RANCHO SANTIAGO COMMUNITY COLLEGE DISTRICT

ADDENDUM NO. 1

Bid #1413 BR Signage and Wayfinding
at
Santiago Canyon College

January 18, 2022

DRAWING TITLE:
SIGN DETAILS

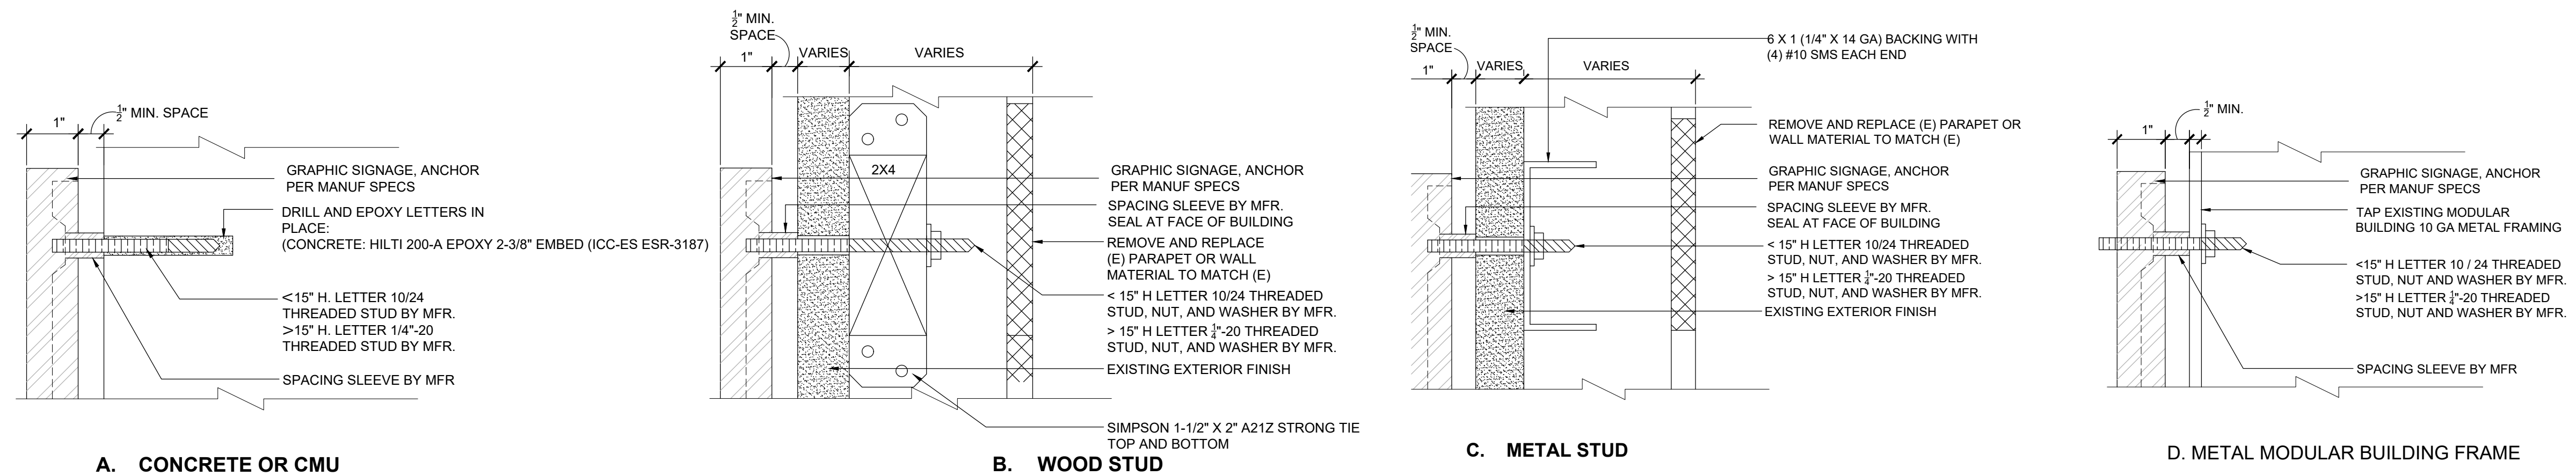
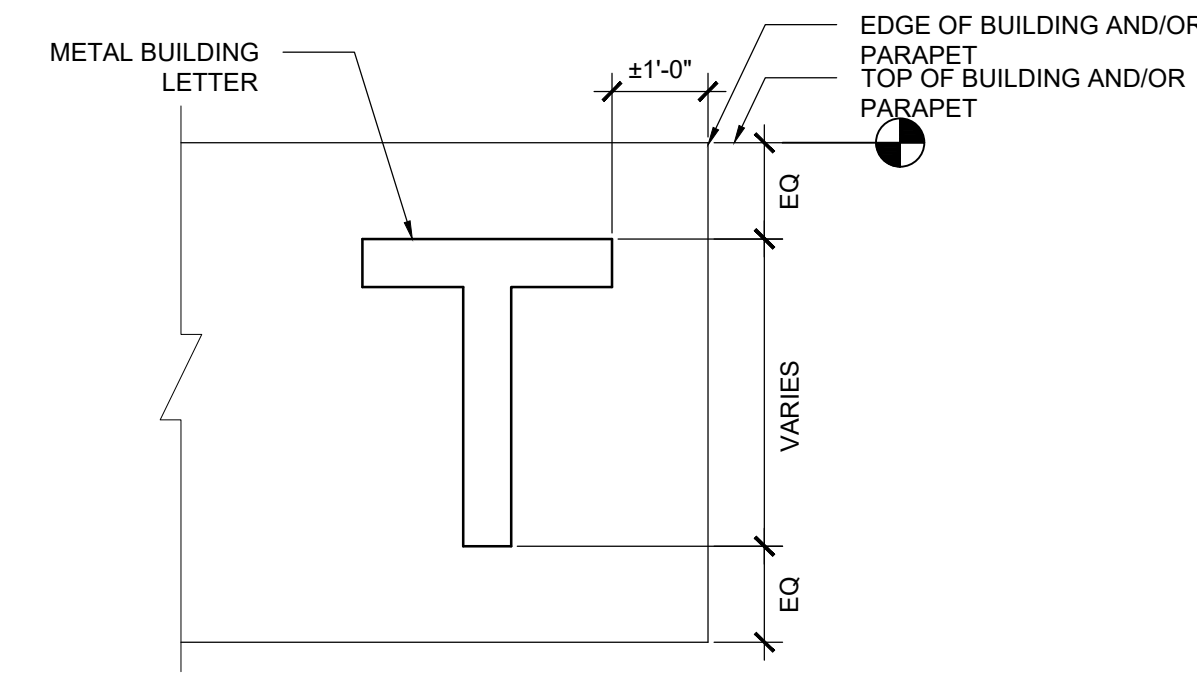
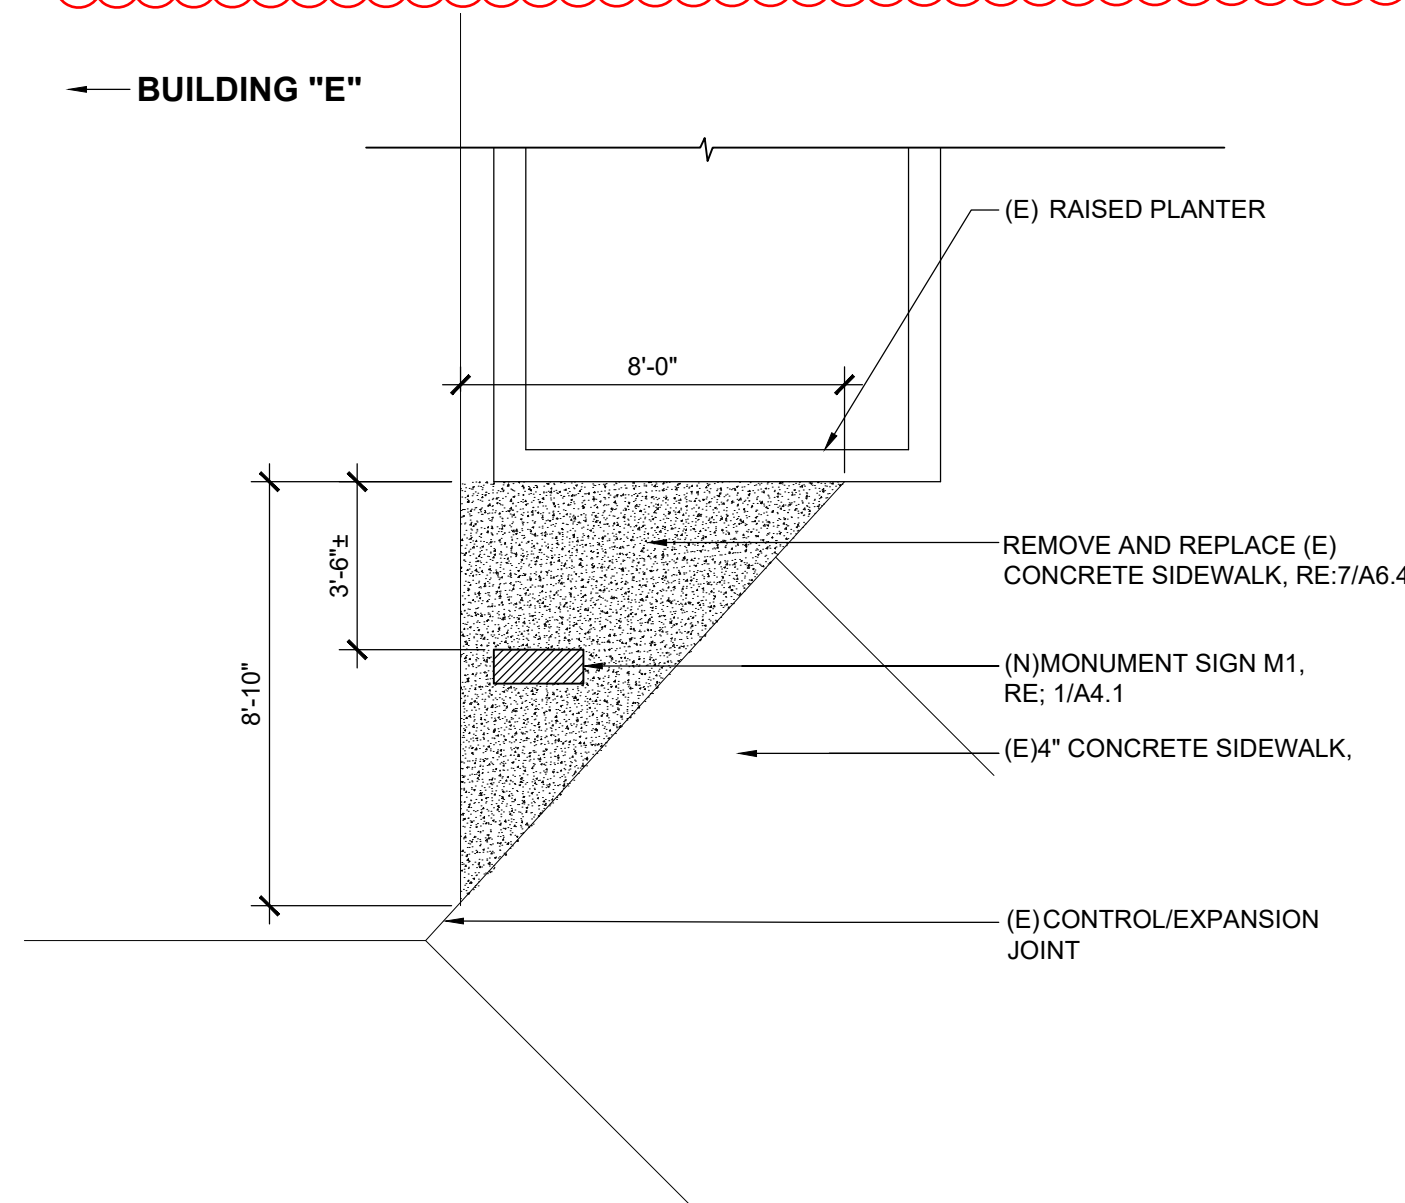
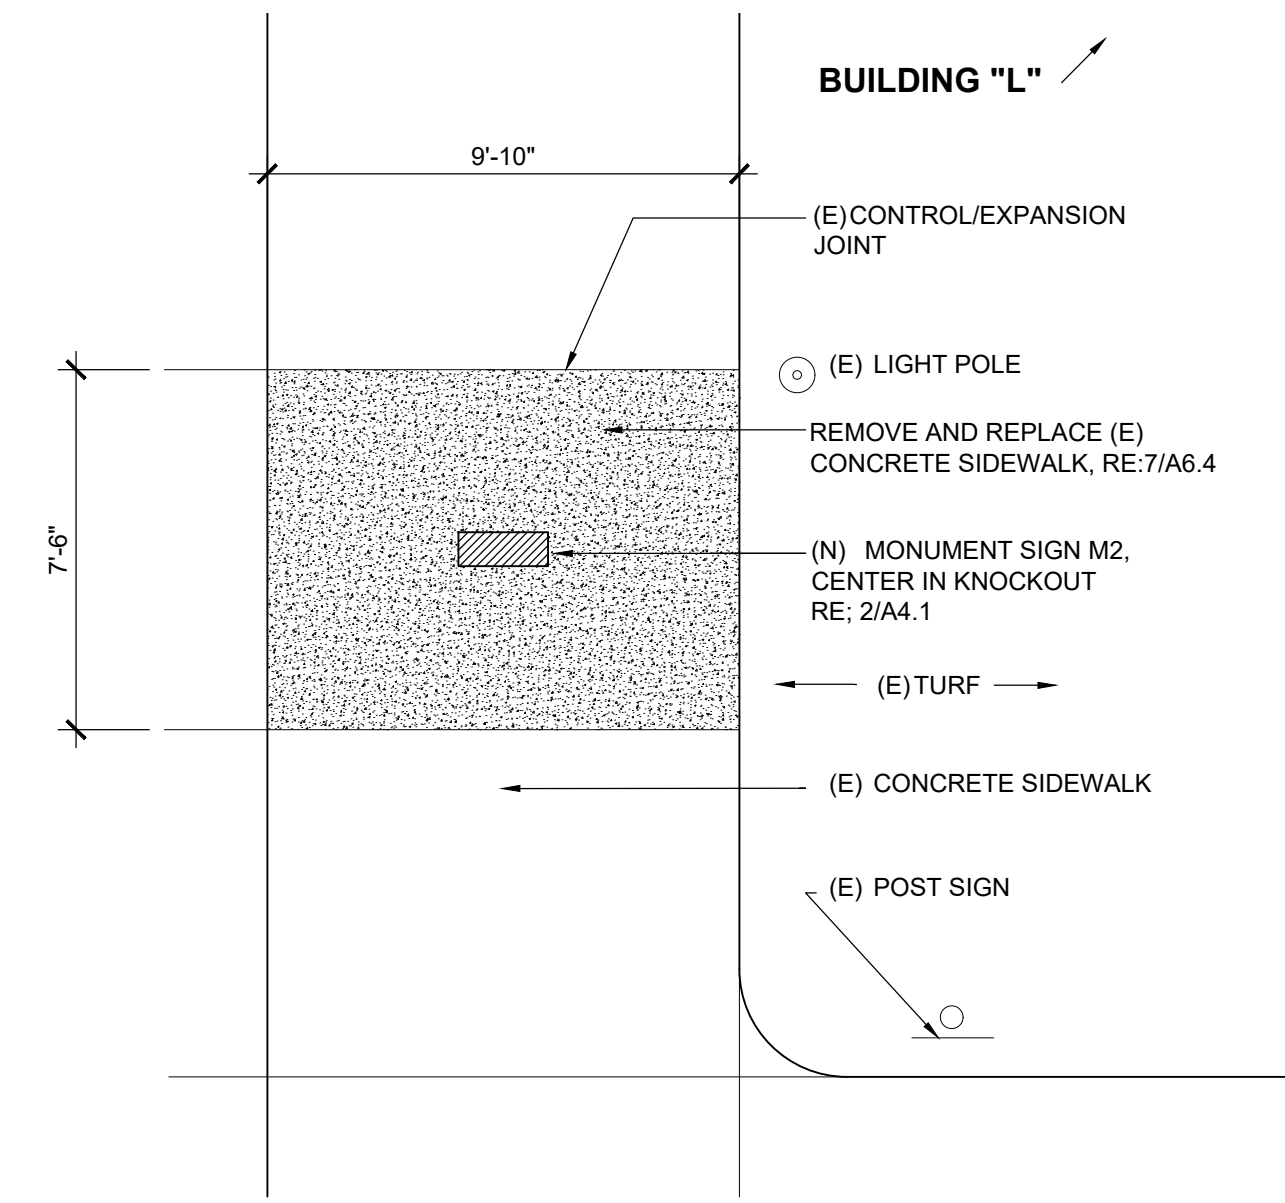
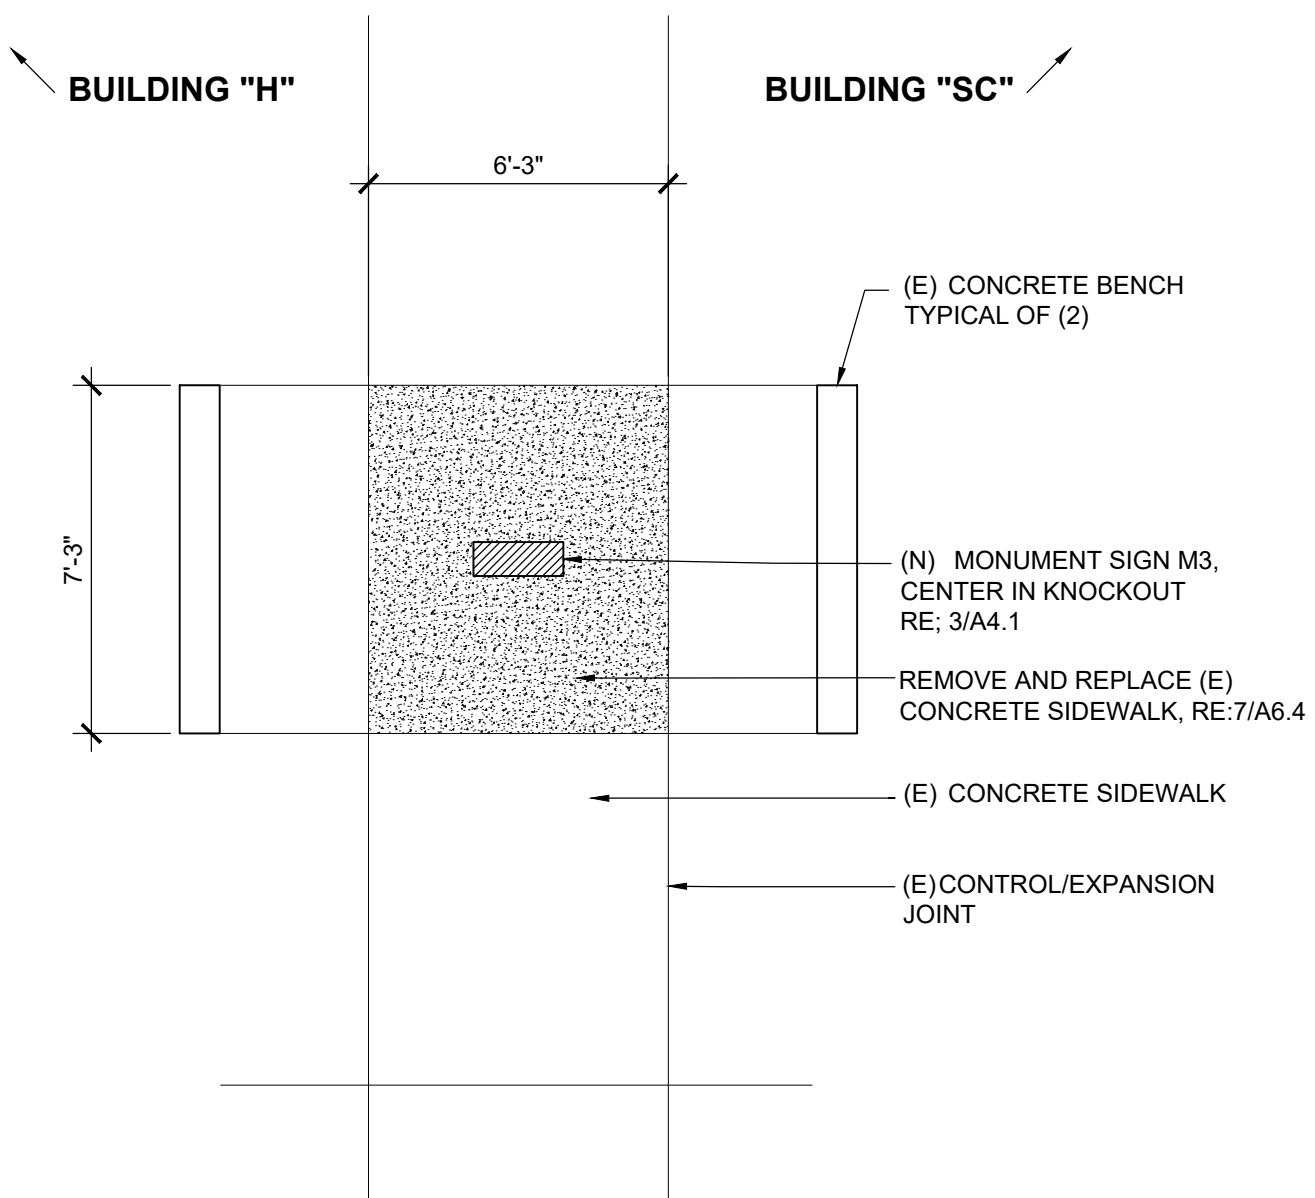
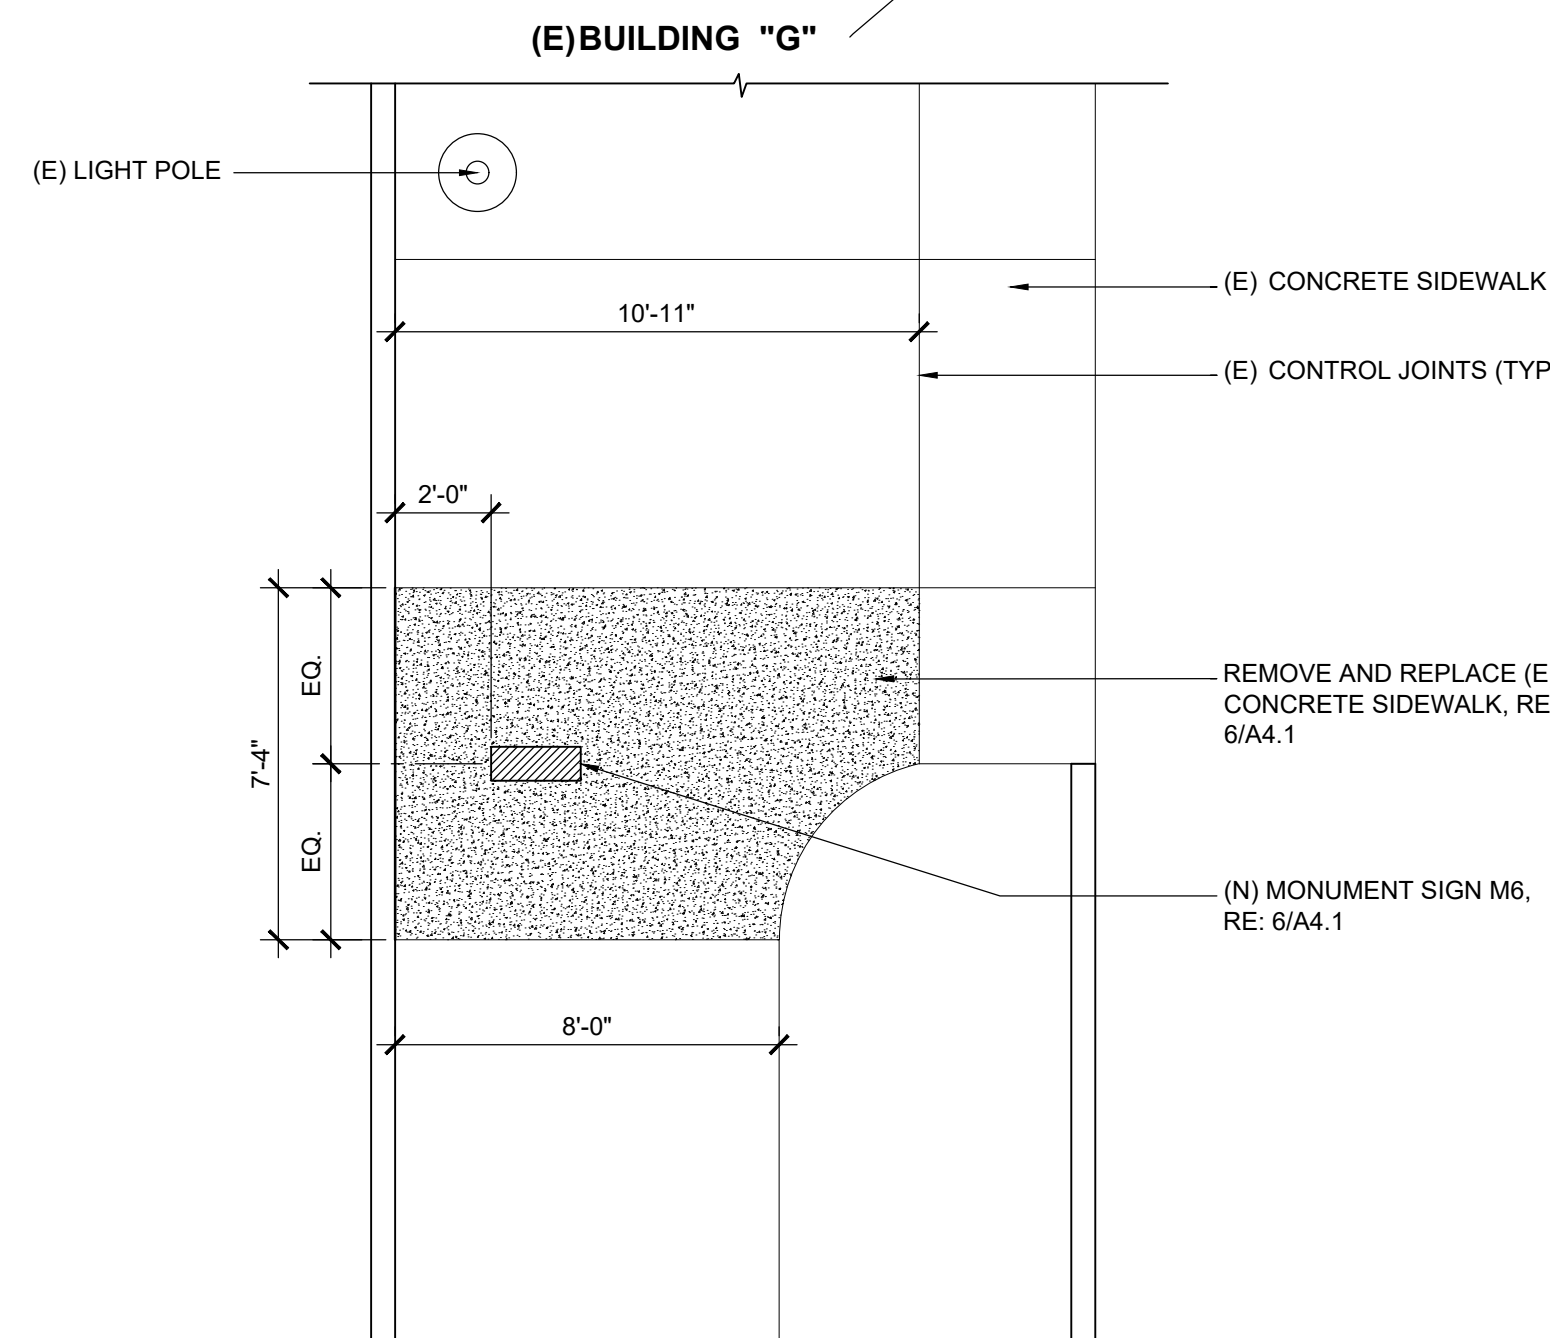
Refer to attached Drawing A6.4, Sign Details. Add General Notes as follows:

1. All installation of signage sleeves is to provide complete water proofing.
2. Provide exterior grade sealant, self-adhering polymer/rubber waterproof membrane or elastomeric acrylic protective coating base on the specific building surface.
3. When drilling and mounting of signage avoid water infiltration between letters, building and anchorage.
